ADDENDUM No. 3 – February 3, 2022

This addendum modifies, amends, and supplements designated parts of the Contract Documents for the above project and is hereby made part thereof by reference and shall be as binding as though inserted in locations designated hereunder.

Volleyball Floor Sleeve Detail

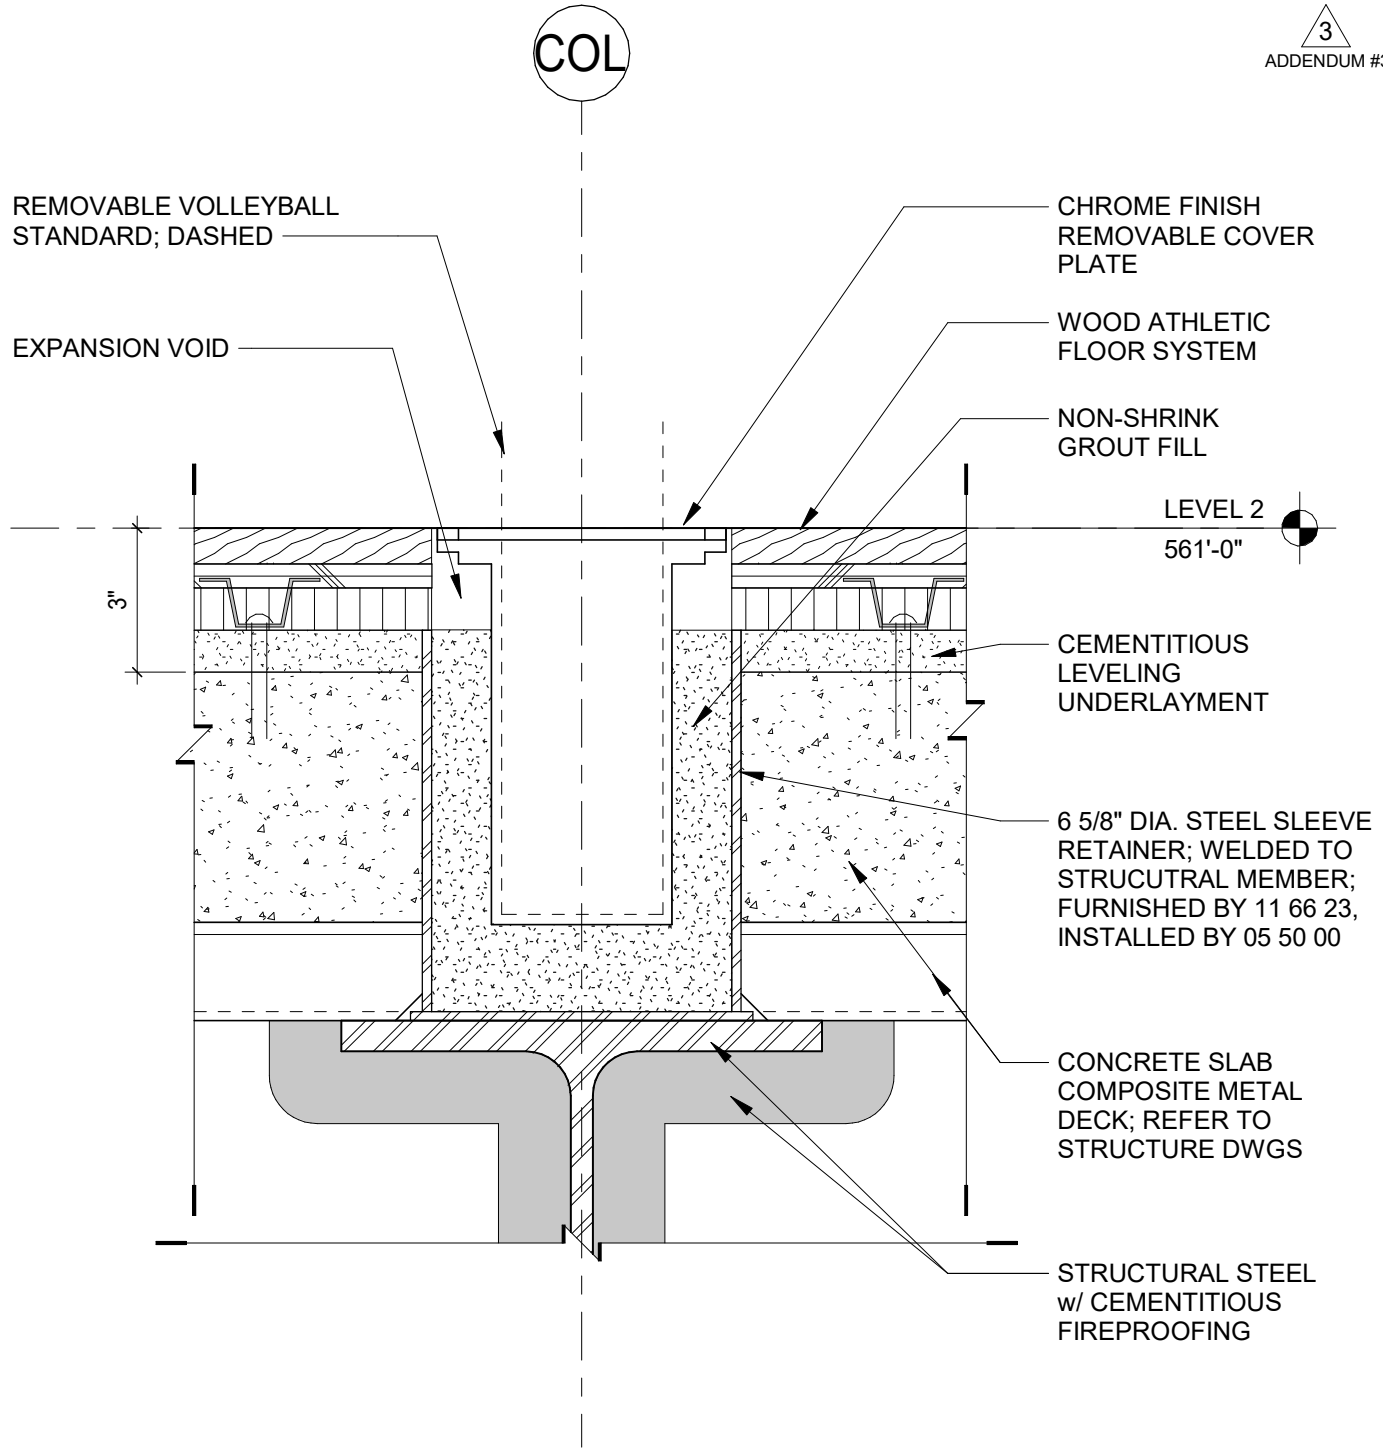
A. Insert new drawing detail 4/A8.26 Volleyball Floor Sleeve Detail, refer to sketch ADD-3/A-008

16
A6.24

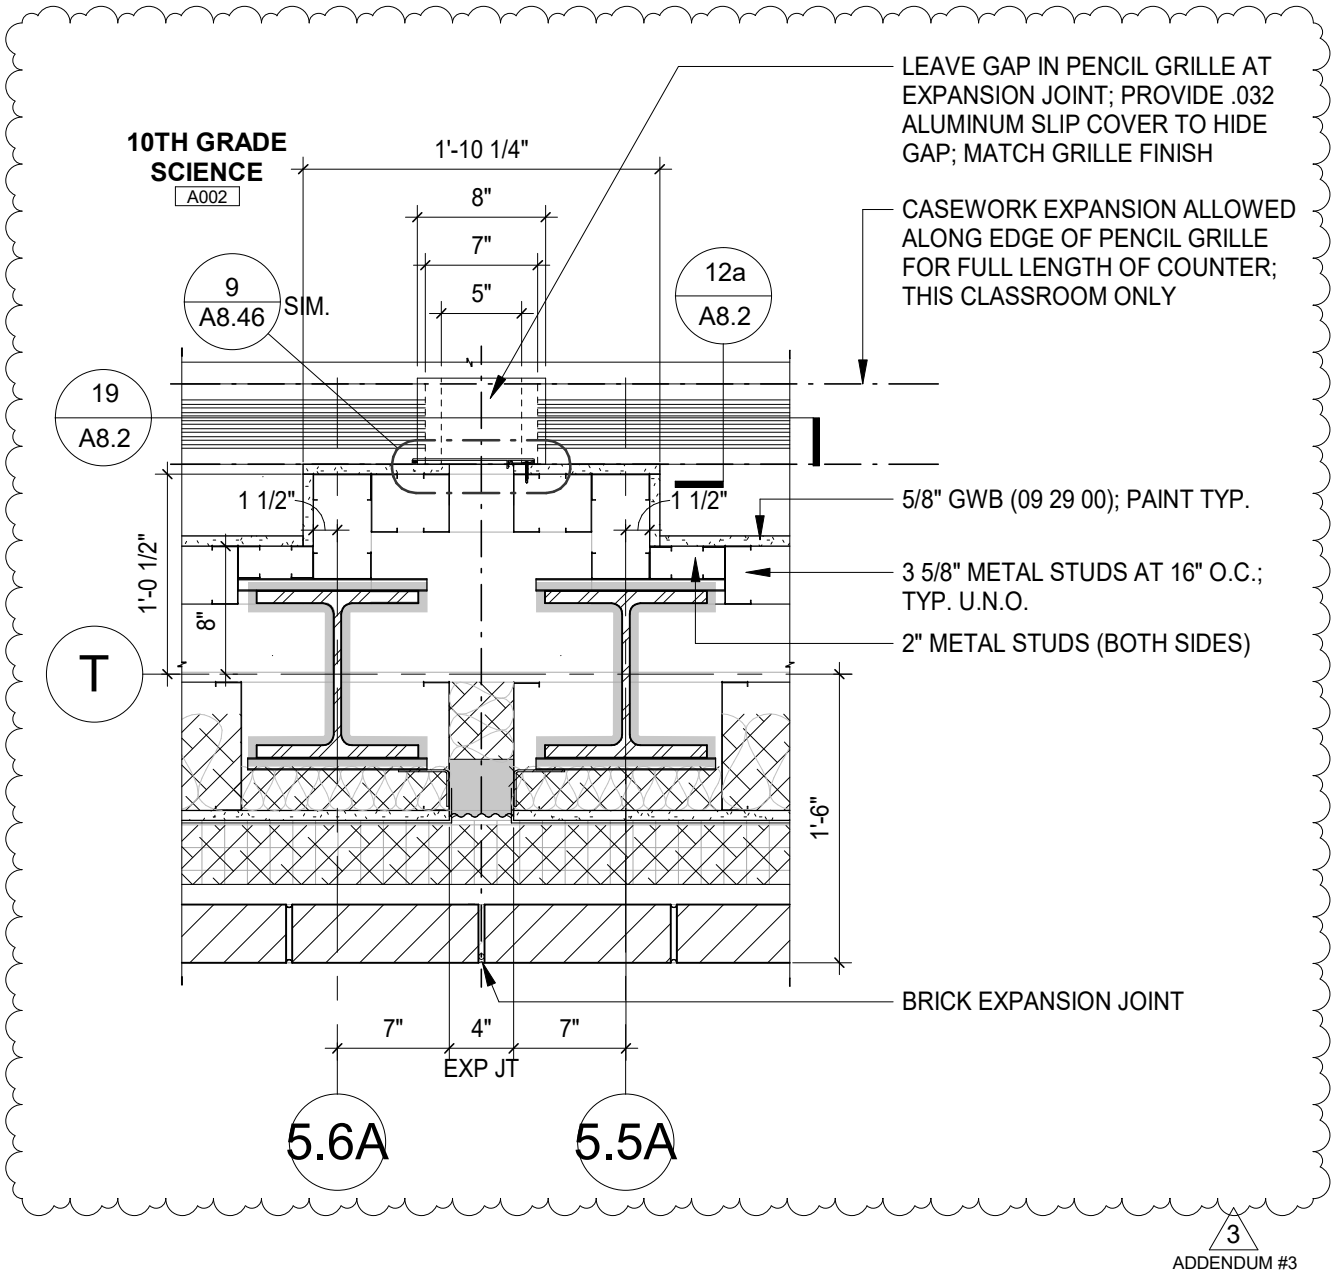
A. Detail 16: Revised to coordinate expansion joint detailing through millwork
   1. Refer to sketch ADD-3/A-006

Partial Main Level Floor Plan - Section CD

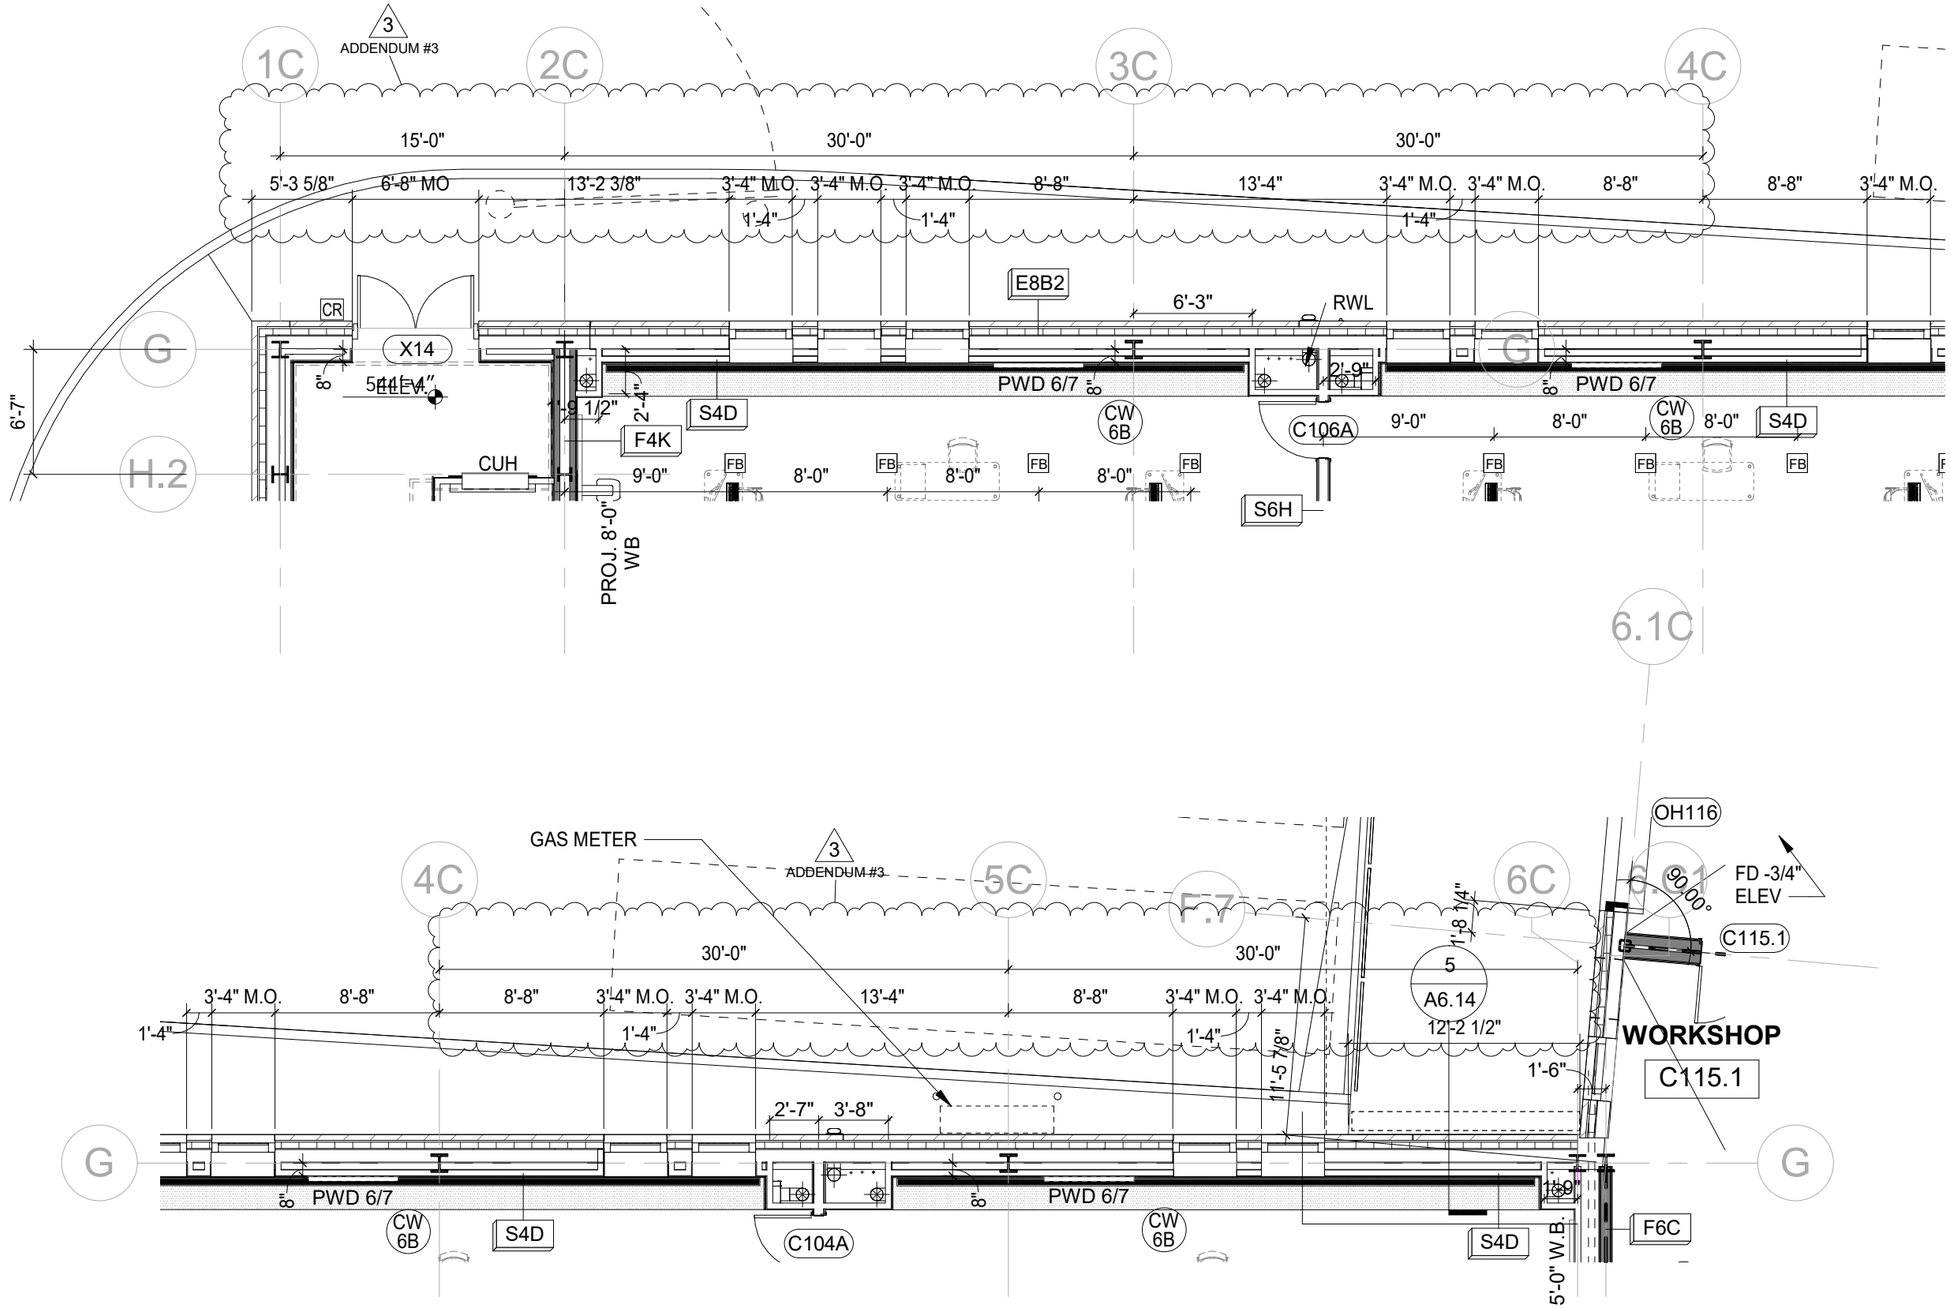
A. At Detail 5, delete overhead generator exhaust stack (shown dashed).

7 / A8.24a Sloped Ceiling Detail at Servery

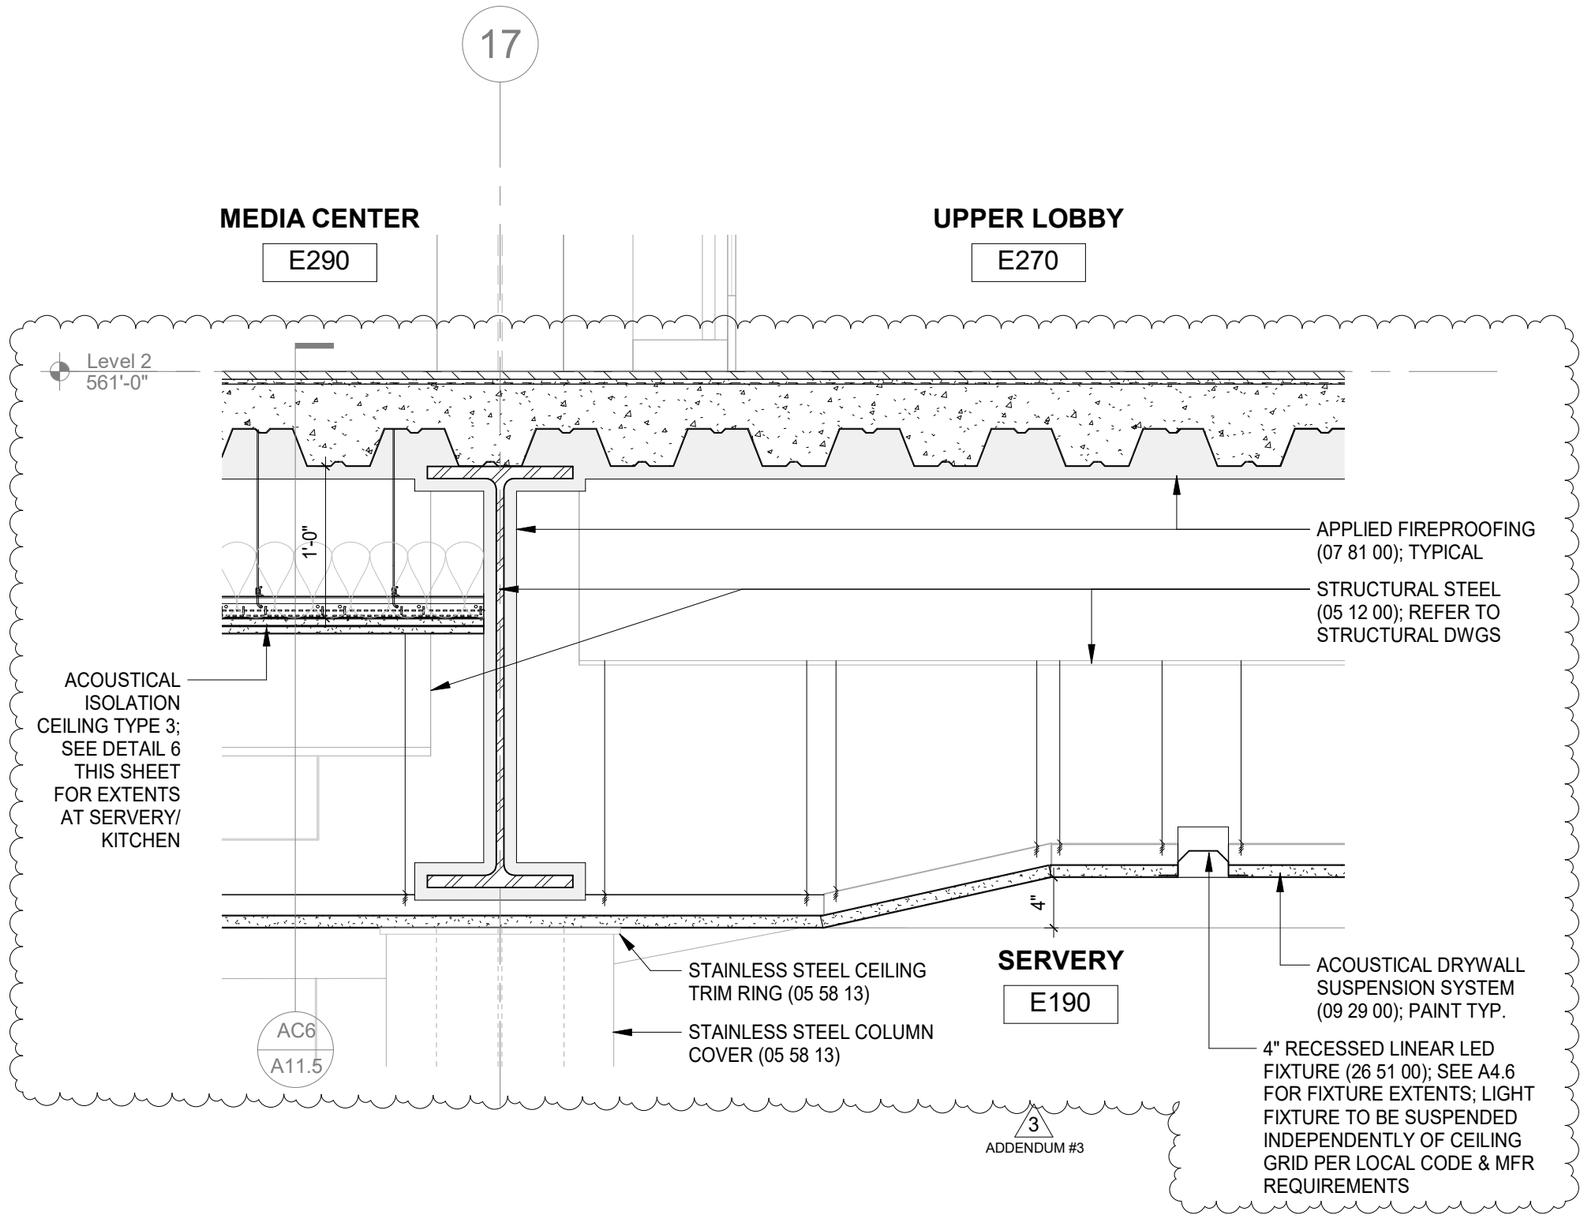
E. Detail 7: add notes to detail; add callout to isolation ceiling type 3 detail (AC6/A11.5); revise installation method from metal stud framing to acoustical drywall suspension grid
1. Refer to sketch ADD-3/A-023

7 / A7.7 Elevation @ Cafeteria Stair/Tiered Seating W-E

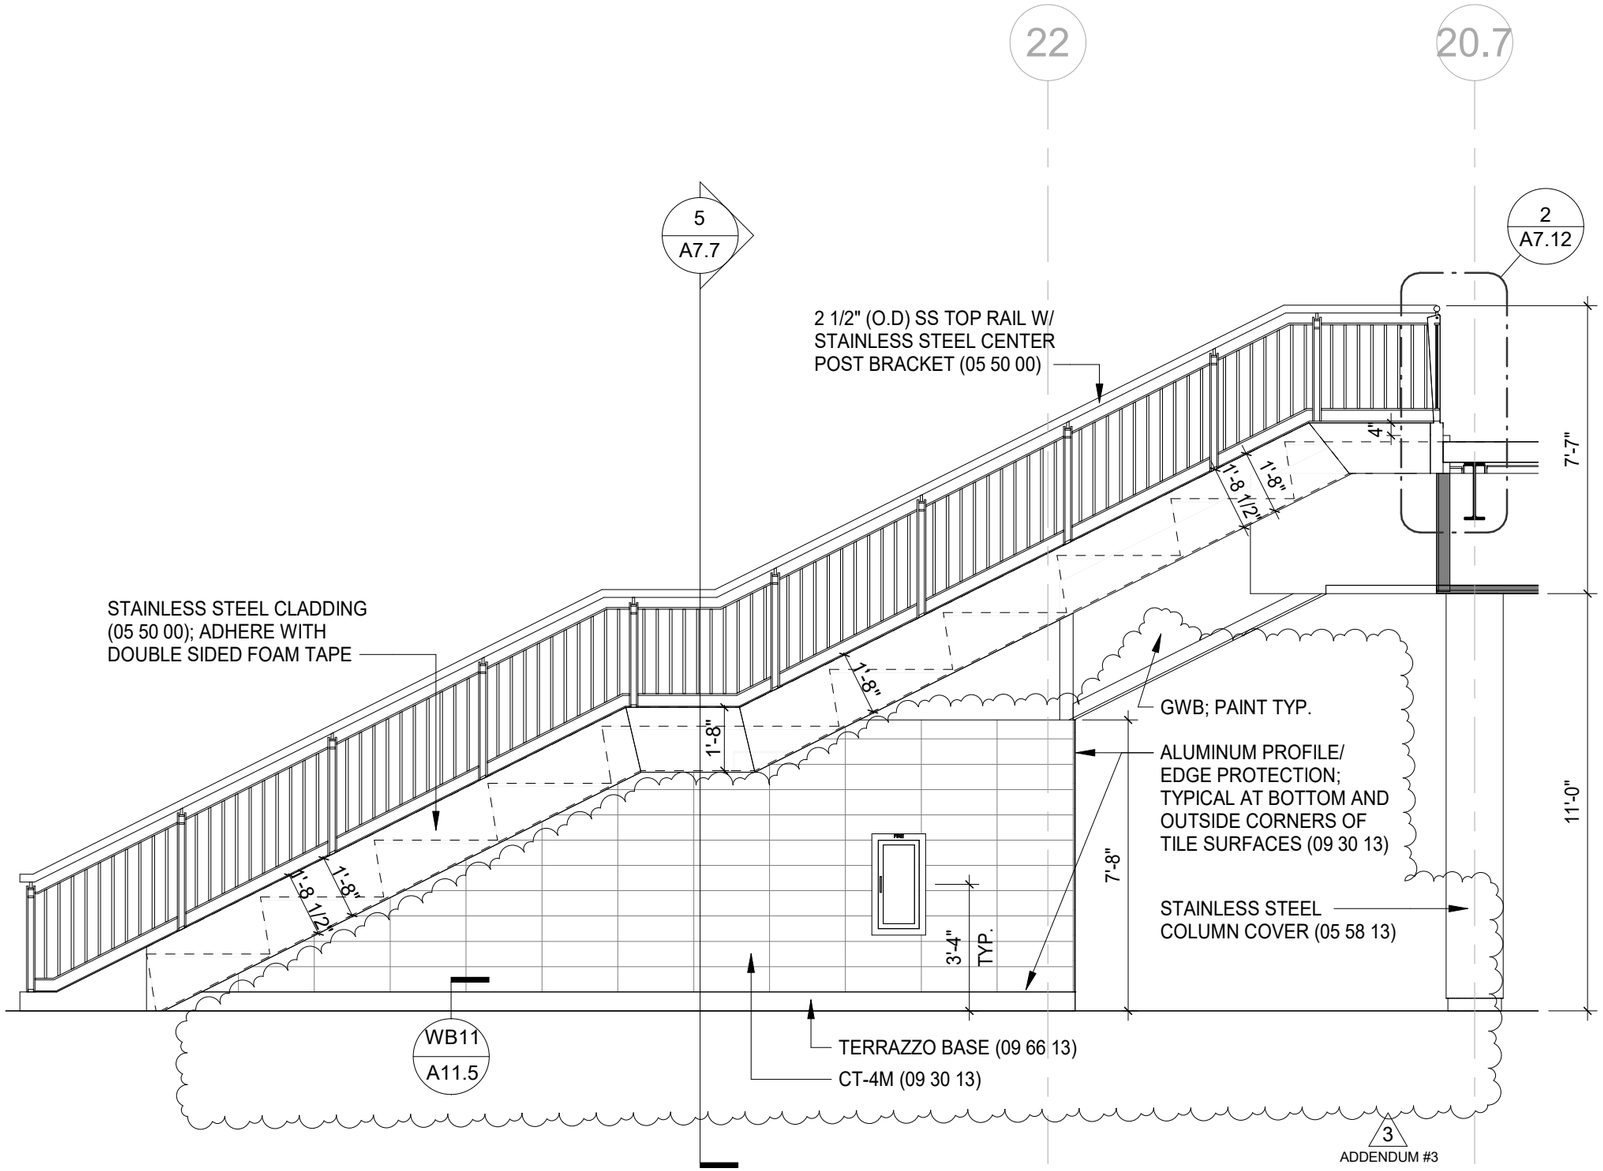
D. Detail 7: Detail revised to clarify wall finishes at exterior of community stair (looking W-E)
